UNITED STATES PATENT AND TRADEMARK OFFICE

APPLICATION NO.	FILING DATE	FIRST NAMED INVENTOR	ATTORNEY DOCKET NO.	CONFIRMATION NO.
10/619,891	07/15/2003	Vincent De Laforcade	NONY 3.0-004	7321

Office Action Summary	Application No.		Applicant(s)	
	10/619,891		DE LAFORCADE, VINCENT	
	Examiner		Art Unit	
	Robyn Doan		3732

DETAILED ACTION

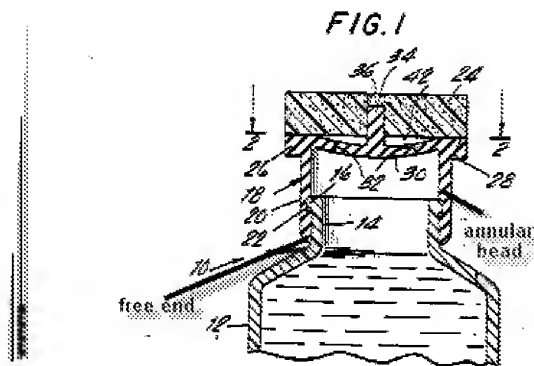
Claims 86, 97 are rejected under 35 U.S.C. 102(b) as being anticipated by Schwartzman (USP 3,410,645).

Schwartzman discloses an applicator (24, fig. 1) comprising fixing means (whole portion of 18) for removably affixing the applicator to a neck (14) of a receptacle (12), the applicator including an assembly skirt with a free end (see below attachment) and an annular sealing bead (see below attachment) formed on an inside surface of the assembly skirt and spaced from the free end, wherein the fixing means being situated between the free end and the annular bead (Applicant is noted that the portion of 18

above the free end portion and below the bead is considered as being in between the free end and the annular bead.
